HISTORIC AND DESIGN REVIEW COMMISSION

HDRC CASE NO: 2017-467
ADDRESS: 423 N HACKBERRY ST
LEGAL DESCRIPTION: NCB 576 BLK 15A LOT N 30.32 FT OF 12
ZONING: RM-4 H
CITY COUNCIL DIST.: 2
DISTRICT: Dignowity Hill Historic District
APPLICANT: John Brearley
OWNER: John and Irene Brearley
TYPE OF WORK: New construction of a 2-story single family home
REQUEST:

The applicant is requesting conceptual approval to construct a new two-story single family home on the vacant lot at 423 N Hackberry.

FRONT ELEVATION

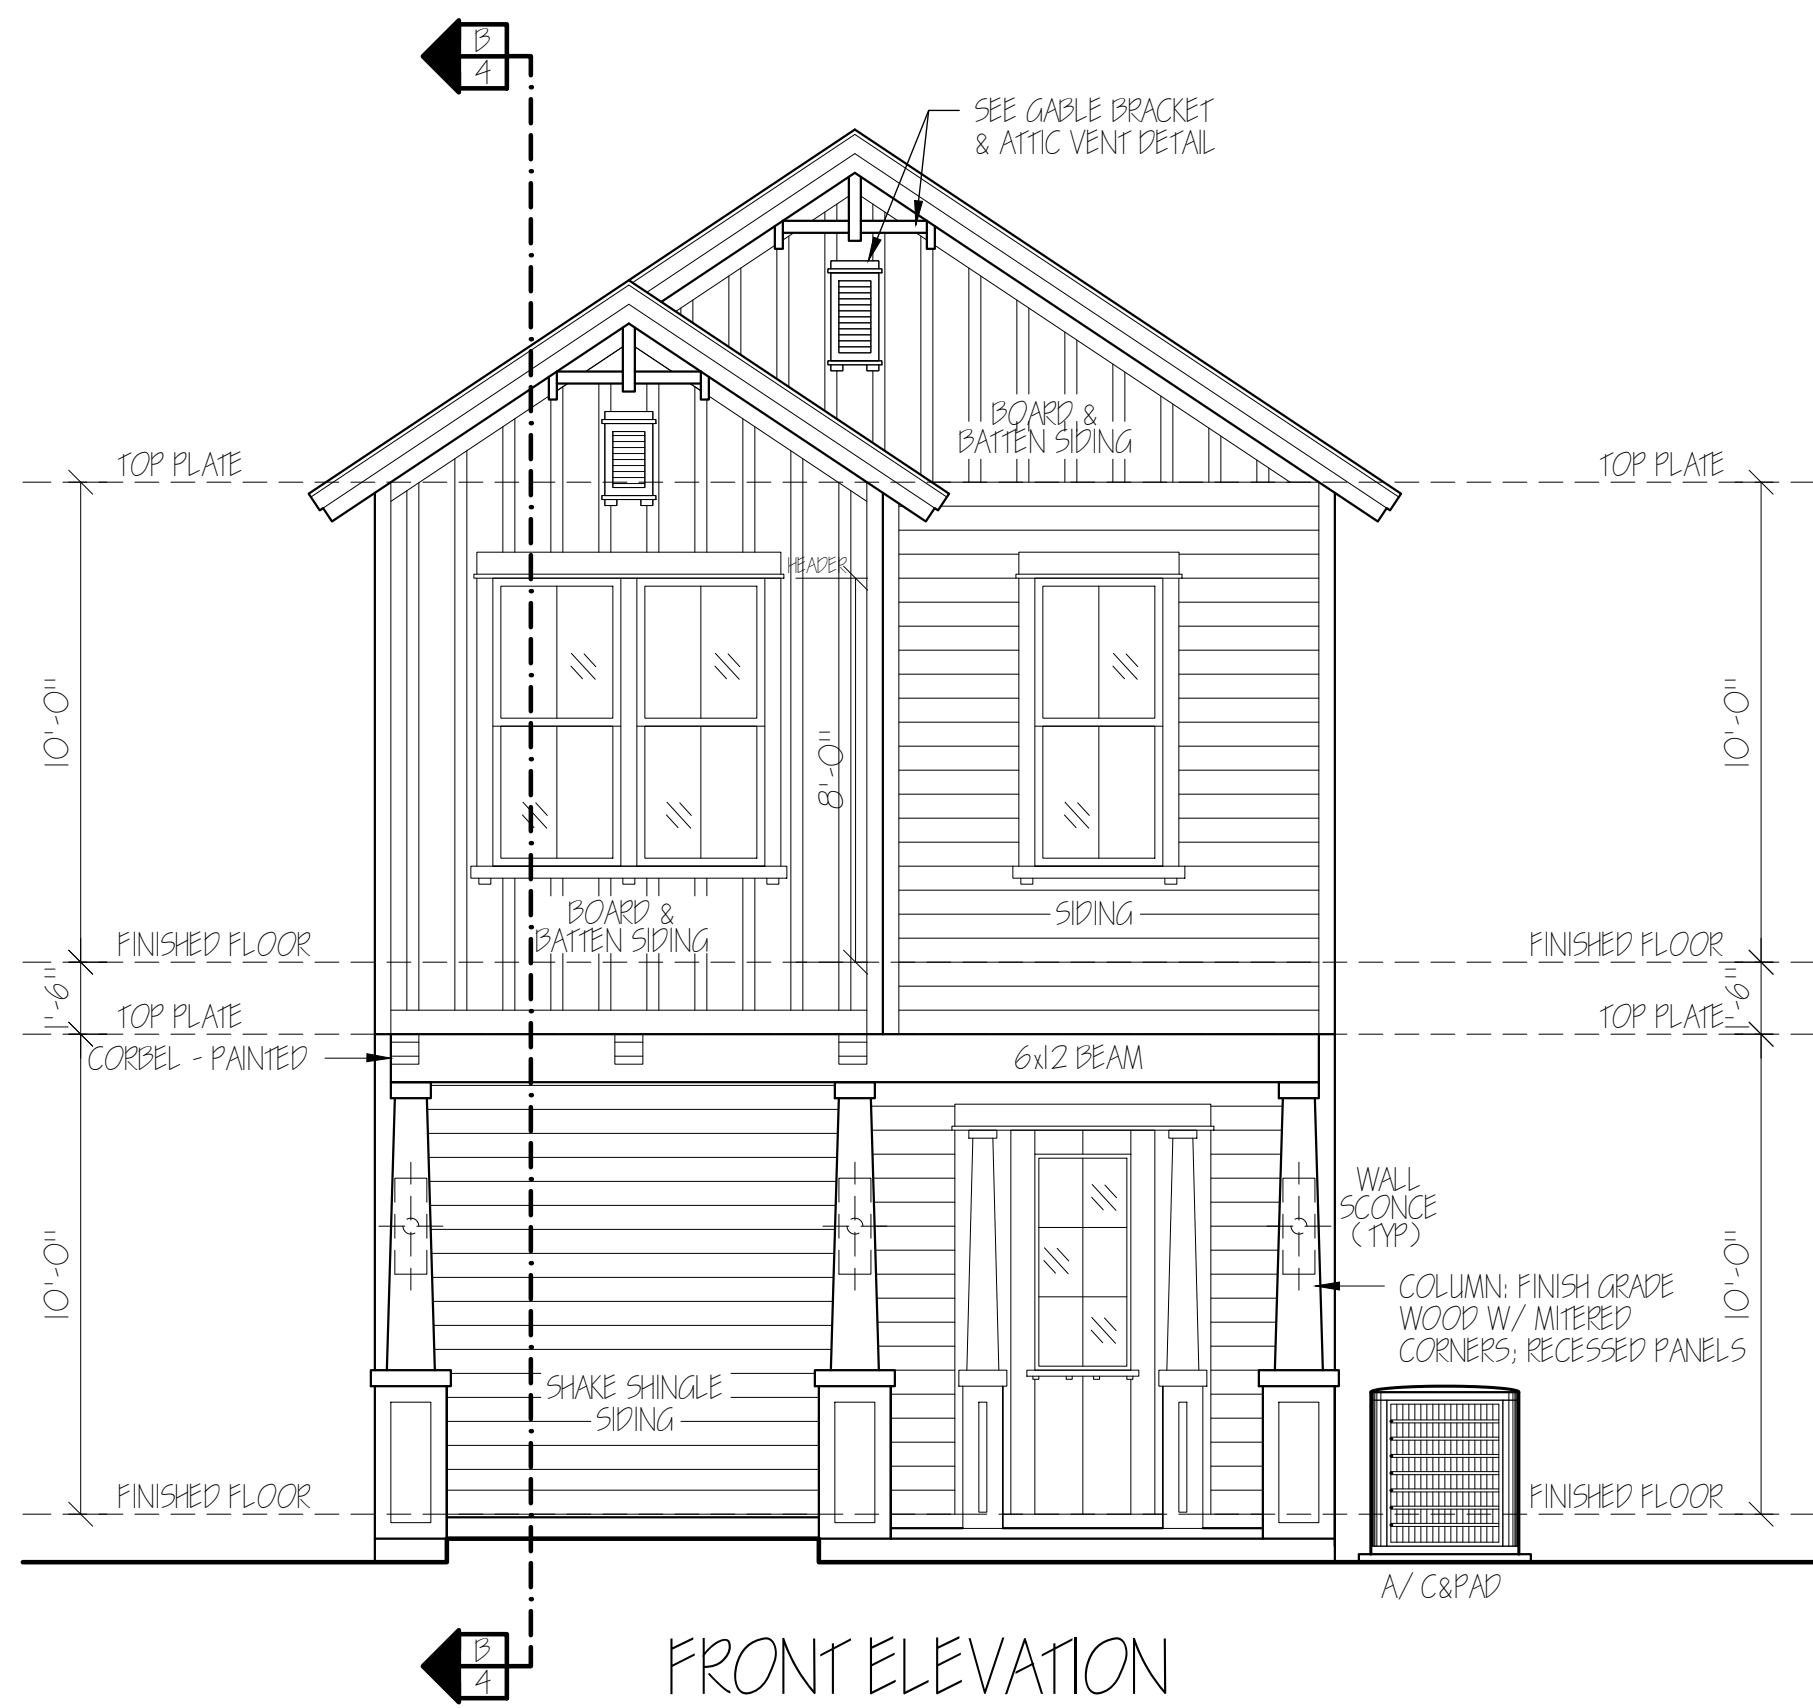
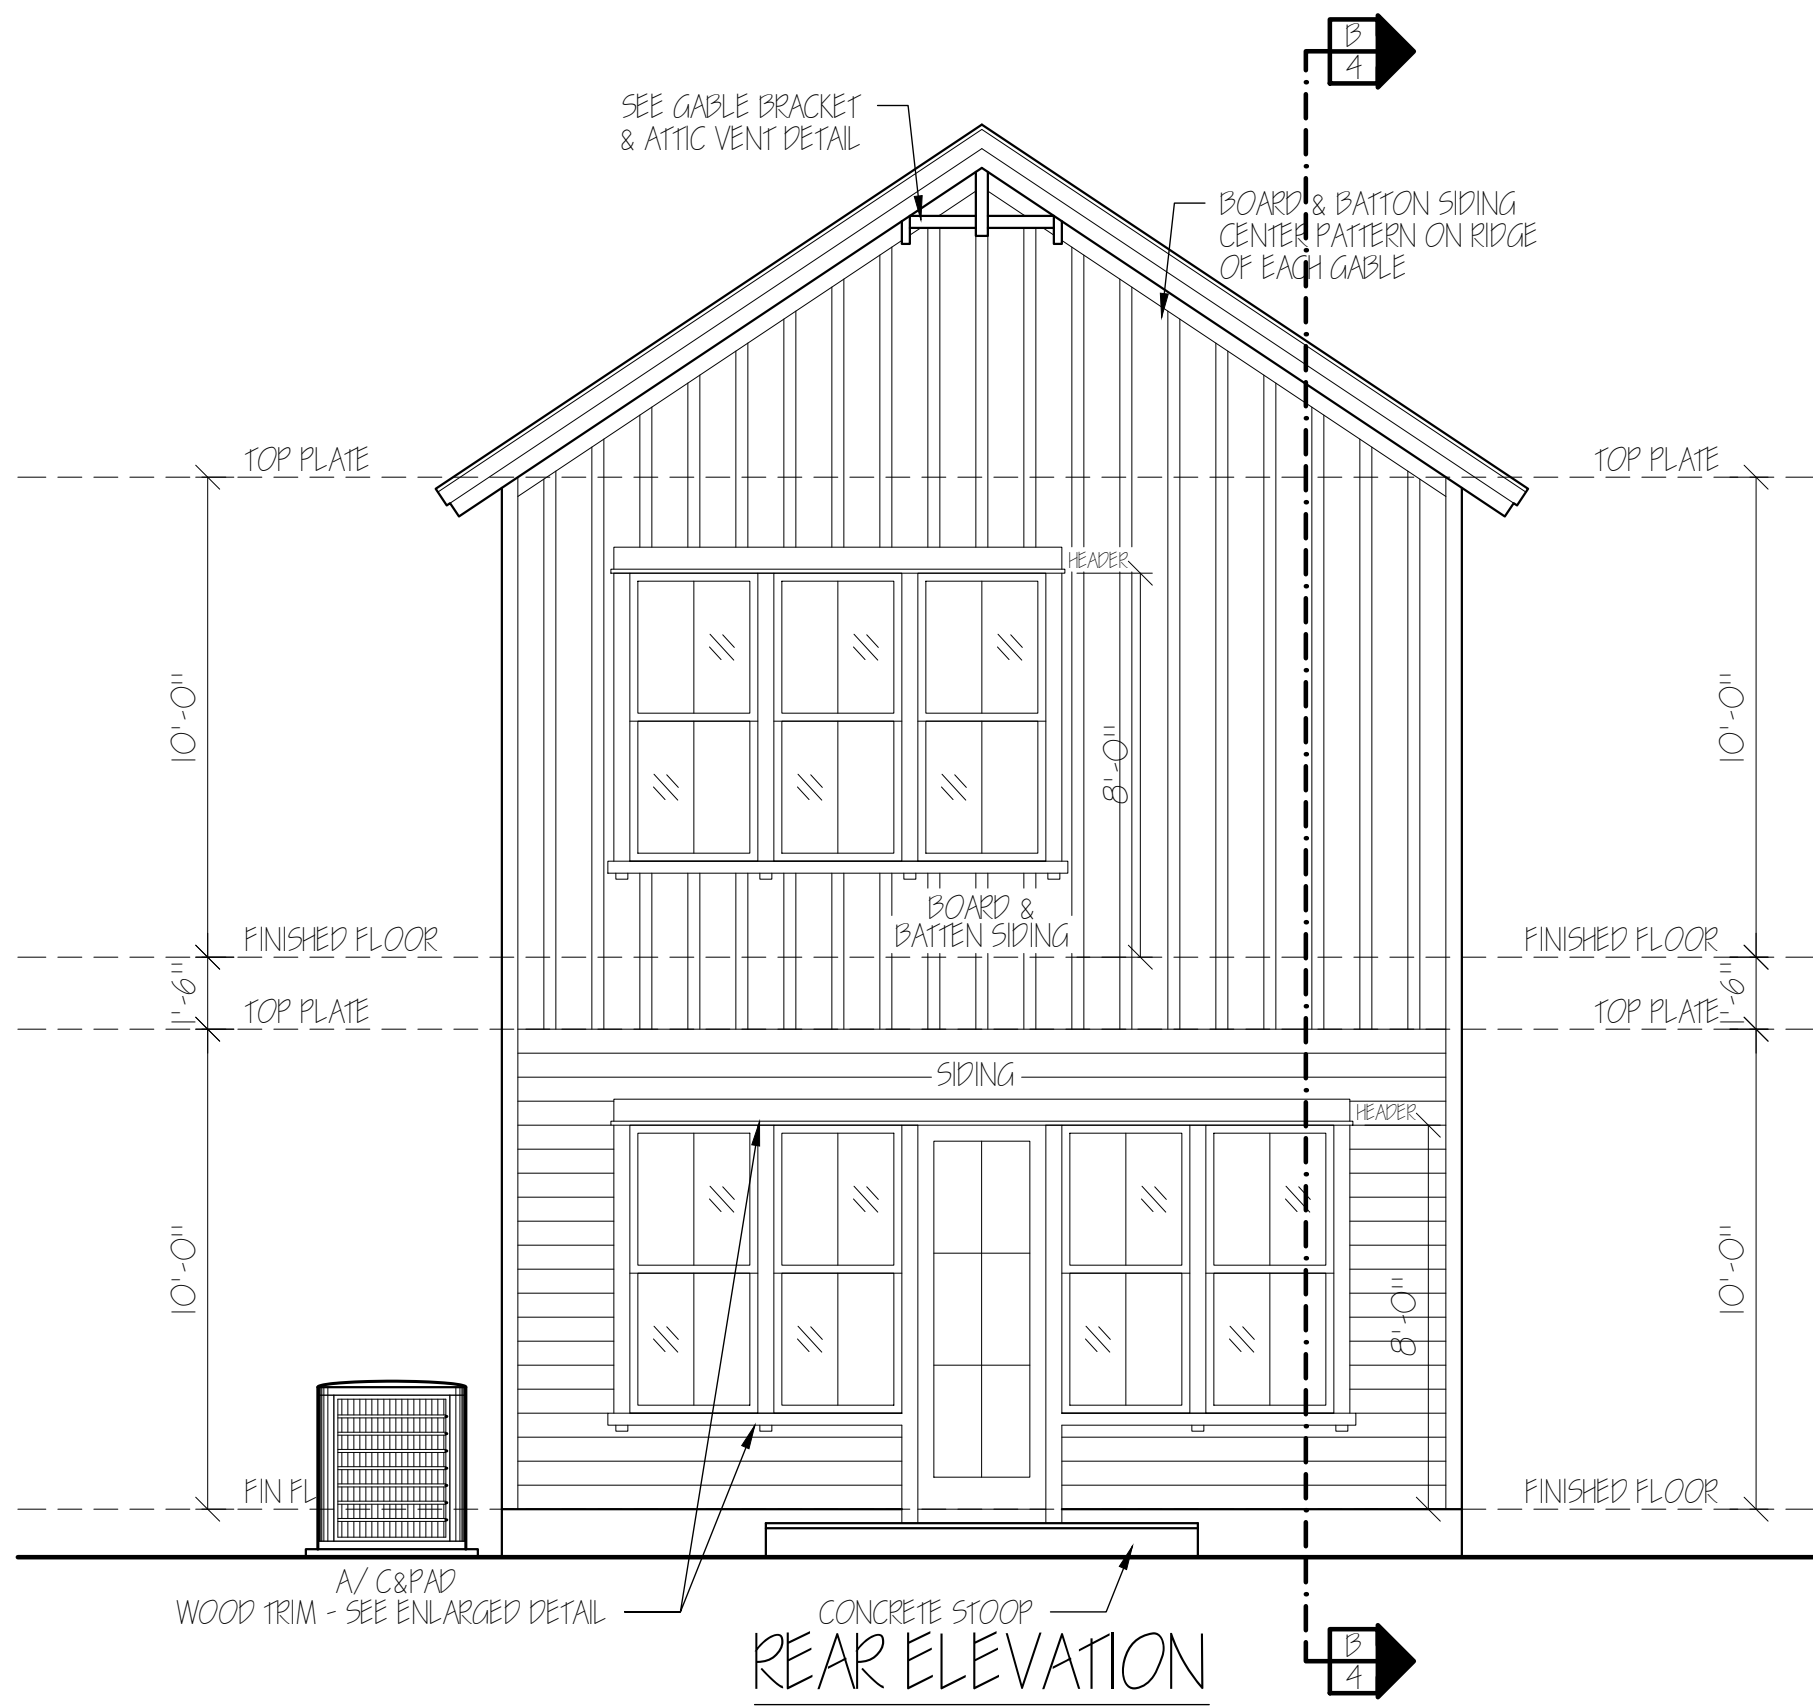
- f. **SCALE & MASS** – Per the Guidelines for New Construction 2.A.i., a height and massing similar to historic structures in the vicinity of the proposed new construction should be used. In residential districts, the height and scale of new construction should not greatly exceed the historic precedent. The only remaining historic residential structure on N Hackberry between E Houston and Glorietta is 2 stories. The remaining historic structures in the vicinity on Glorietta are 1-story. The applicant has noted on the submitted drawings that the proposed ridge line will be 28'-10" from the finish floor, which is approximately one foot from grade, bringing the total height to approximately 29'-10" feet. Both the first and second stories will feature 10'-0" tall interior ceiling heights separated by a web truss measuring 1'-6". The neighboring 2-story historic structure features a first floor ceiling height of 10'-0" and a second floor ceiling height of 8'-0". Staff does not find the proposed height to be consistent with the Guidelines. Staff finds that the overall height should be reduced through the shortening of the second story or the lowering of the top plate height to produce an overall height that is comparable with the heights of neighboring, historic structures.

- g. **PORCH CONFIGURATION AND MASSING** – The applicant has proposed to incorporate a front porch on the front façade of the new structure. The porch mass will be inset approximately 6" from the front façade. The Historic Design Guidelines state that porches on new construction should be reflective of the development pattern of the district. Typically in historic districts, including Dignowity Hill, residential porch massing elements project the furthest towards the streetscape to engage pedestrians. Two story structures feature a second story that is set back from the porch. As proposed, the structure's second story extends over the front porch, which increases the massing on the street. This is addressed in Guideline 2.A.ii, which states that step-downs in building height, wall-plane offsets, and other variations in building massing to provide a visual transition should be utilized. There is no historic precedent in the district for this porch form or massing strategy. Staff finds the porch inconsistent with the Guidelines.

- 1. That the applicant provides information noting the setbacks of adjacent historic structures on a contextual site plan.
- 2. That the applicant reduces the proposed height through the shortening of the second story or the lowering of the top plate height to produce an overall height that is comparable with the heights of neighboring historic structures.
- 3. That the applicant sets the second story back from the front façade and modifies the front porch configuration and

massing as noted in finding g. The porch should be the mass that projects furthest towards the streetscape to reflect the developmental context of the area.
